Council Reference: GT1/52  
Your Reference: D17/5682

1 June 2017

**NWS LICENCE APPLICATION UNDER THE WATER INDUSTRY  
COMPETITION ACT 2006 (NSW) FOR THE COBAKI ESTATE -  
TWEED SHIRE COUNCIL SUBMISSION**

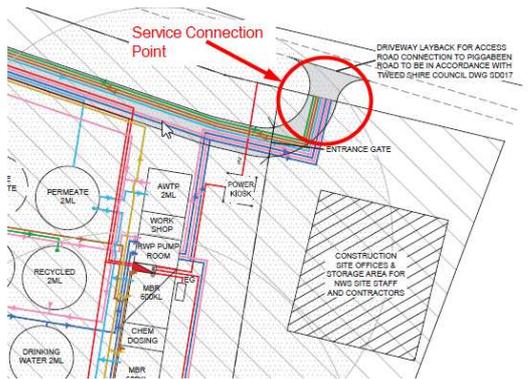
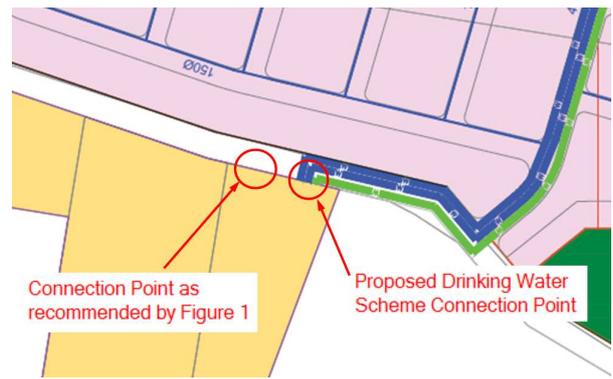
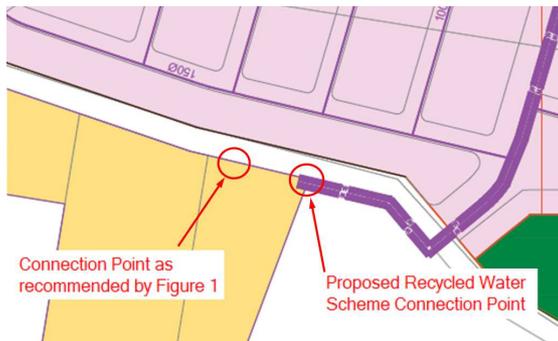
There are a number of inconsistencies between various documents in terms of the location of infrastructure / pipework within the WWTP site. For instance, the service connection points are recommended as per Figure 1 below, yet the Drinking Water Scheme (Figure 2), Recycled Water Scheme (Figure 3) and Pressure Sewer Scheme (Figure 4) identify different locations at the entry point of the WWTP site.

All documentation needs to be revised to ensure consistency with the recommendations of the Flora and Fauna Assessment (Appendix K of the REF) to avoid impact upon large existing vegetation.

**Figure 5 □ Site Layout**

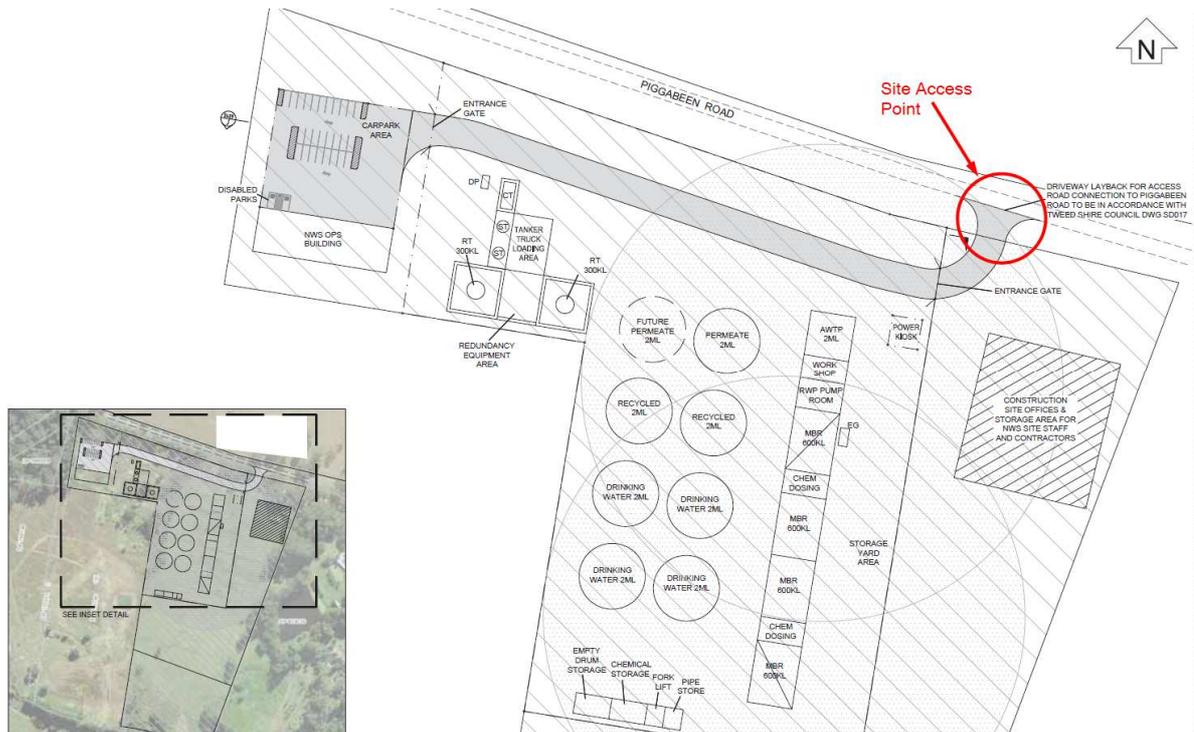
There are also inconsistencies between documents in terms of the site configuration. The Site Layout Plan (Revision D) in Appendix B of the REF indicates an eastern access point for the site (as shown in Figure 5 below), which accords with the Flora and Fauna Assessment (Attachment K of the REF) to avoid impact upon large existing trees. There are a number of supporting documents that do not incorporate the latest site design.

All documentation needs to be revised to ensure consistency with the design plans (Appendix B) and the recommendations of the Flora and Fauna Assessment (Appendix K).

Figure 6 □ SWMP

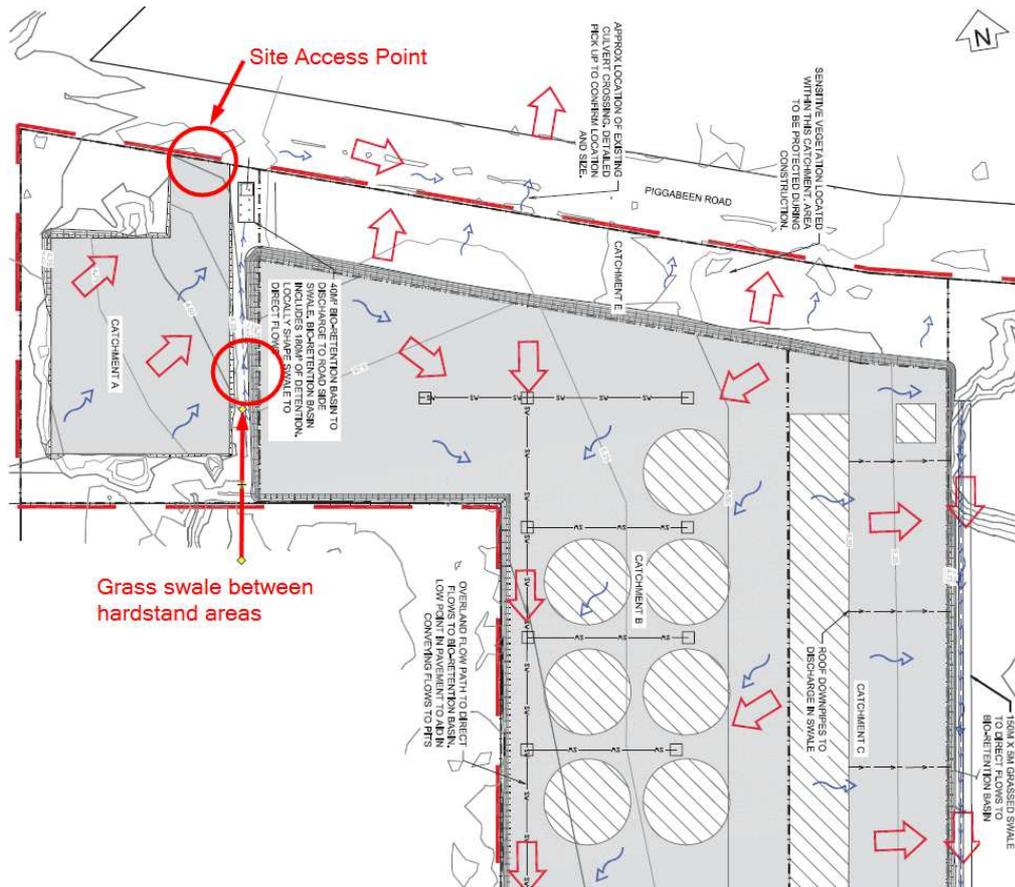
Inconsistencies have also been identified between the Site Layout Plan (Appendix B) and Stormwater Management Plan (Attachment E of the REF □ Figure 6 below) and the Statement of Landscaping Intent (Appendix O of the REF □ Figure 7 below).

In addition to inconsistencies with the site access point, Figures 6 and 7 differ from the proposed Site Layout Plan in terms of the grass swale requirements for stormwater drainage purposes. All documents need to be consistent in terms of site access, driveway location and stormwater requirements.
